June 15, 2011

**Re: *North American Electric Reliability Corporation*
Docket No. _____**

The North American Electric Reliability Corporation (“NERC”) hereby submits this petition in accordance with Section 215(d)(1) of the Federal Power Act (“FPA”) and Part 39.5 of the Federal Energy Regulatory Commission’s (“FERC” or the “Commission”) regulations seeking:

- approval of Reliability Standard FAC-008-3 — Facility Ratings and the associated Violation Risk Factors and Violation Severity Levels (FAC-008-3), which is included in **Exhibit A** to the petition, effective the first day of the first calendar quarter that is twelve months following the effective date of a Final Rule in this docket;¹
- approval of the implementation plan for Reliability Standard FAC-008-3 — Facility Ratings which is included in **Exhibit B** to the petition; and
- approval of the retirement of two Reliability Standards effective midnight immediately prior to the first day of the first calendar quarter that is twelve months following the effective date of a Final Rule in this docket:

**Diagram 1 – Facility with Three Pieces of Equipment
Determination of Rating
For Different Periods of Time**

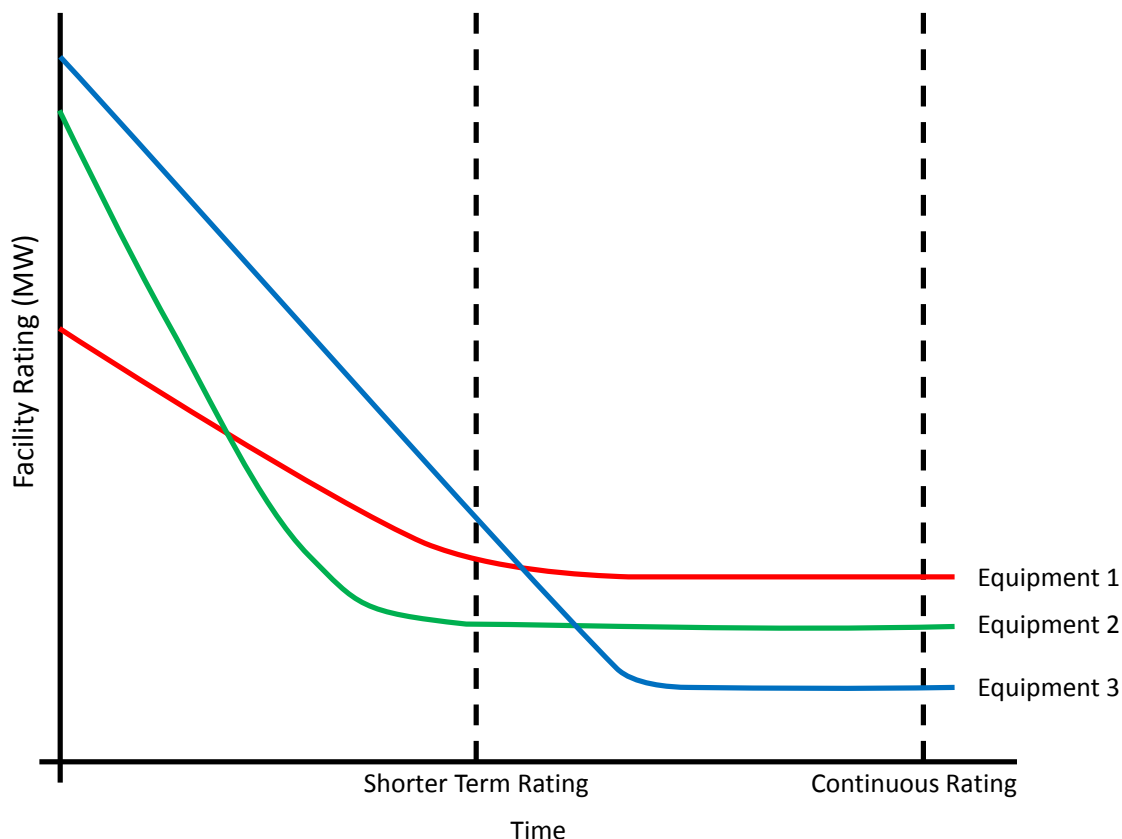
For this example, Requirement 8, Part 2 and its sub-parts requires a Transmission Owner (and the Generator Owner that must comply with Requirement R2) to provide four data points upon request for a specific subset of Facilities.

- For the Continuous Rating: Identification of the existing next most limiting equipment of the Facility (E2) and its Equipment Rating.
- For the Shorter Term Rating: Identification of the existing next most limiting equipment of the Facility (E1) and its Equipment Rating.
